UNITED STATES PATENT AND TRADEMARK OFFICE

10/576,963

Brian K. Paul

Office Action Summary	Application No. 10/576,963	Applicant(s) PAUL ET AL.	
	Examiner ERIN B. SAAD	Art Unit 1793

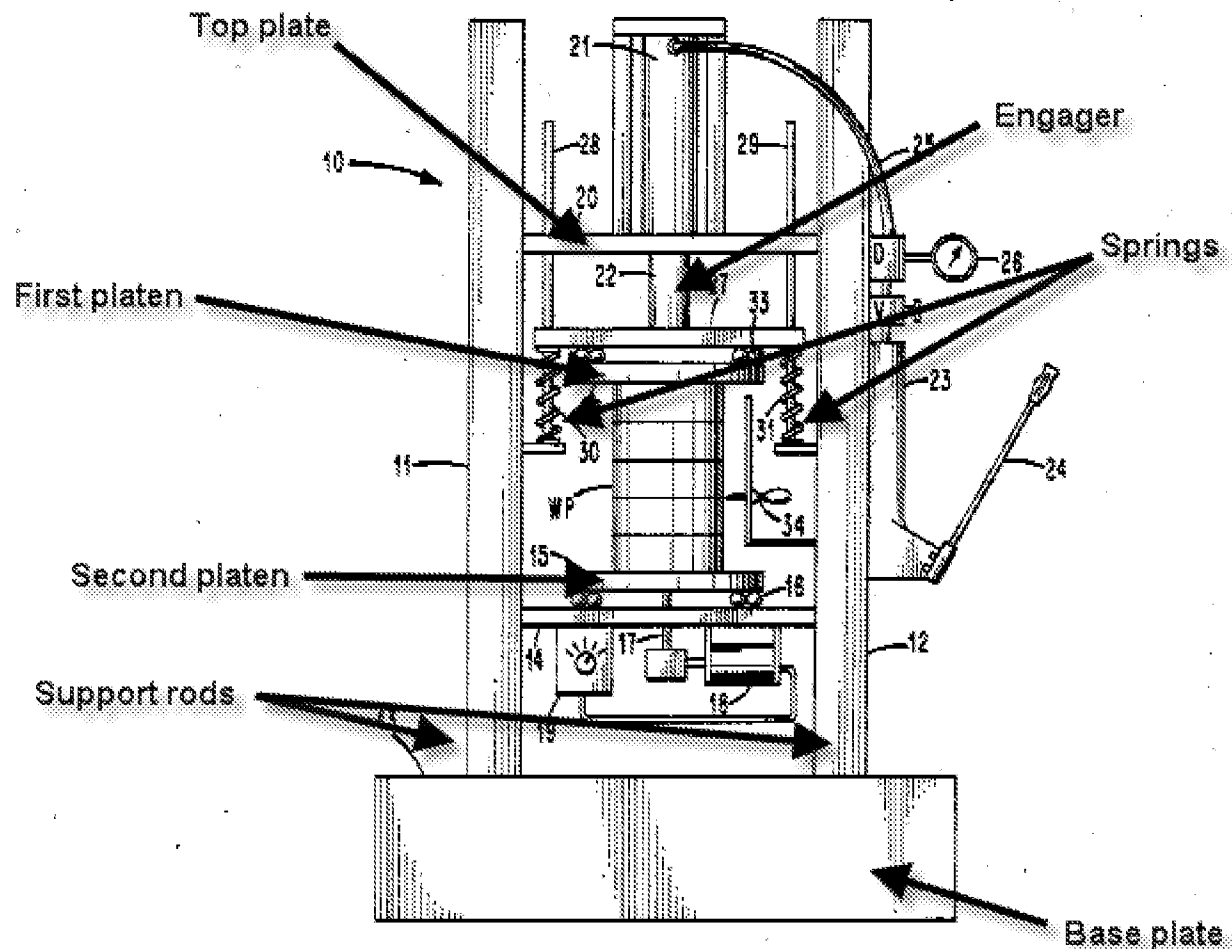
Regarding claim 17, Barry discloses a method for bonding laminae (WP) together to form a device comprising providing a thermally assisted bonding unit comprising an engager 22 having at least one fluid expansion unit and bonding laminae together using the device (column 1 line 46 to column 2 line 55 and figure 1).

Regarding claim 29, Barry discloses that the thermally assisted bonding unit further includes a bottom plate 13, a top plate 20 and where the at least one engager 22 is positioned between the bottom plate and the top plate (column 1 line 46 to column 2 line 55 and figure 1).

Regarding claim 30, Barry discloses that the thermally assisted bonding unit further includes at least one pressure regulating spring 31 positioned between the bottom plate 13 and the at least one engager 22, and where laminae (WP) are positioned between the at least one pressure regulating spring 31 and the at least one engager 22 (column 1 line 46 to column 2 line 55 and figure 1).

Regarding claim 67, Barry discloses that the thermally assisted bonding unit further comprises a frame having a base plate 13, a top plate 20, and support rods 11, 12 positioned between the bases plate and the top plate, the support rods coupling the top plate and bottom plate, with the engager 22 positioned between the base plate and the top plate; and a first platen 32 and a second platen 15 positioned between the at least one engager and the bottom plate, the first platen contacting an upper surface of the laminae and the second platen contacting a lower surface of the laminae (shown below).
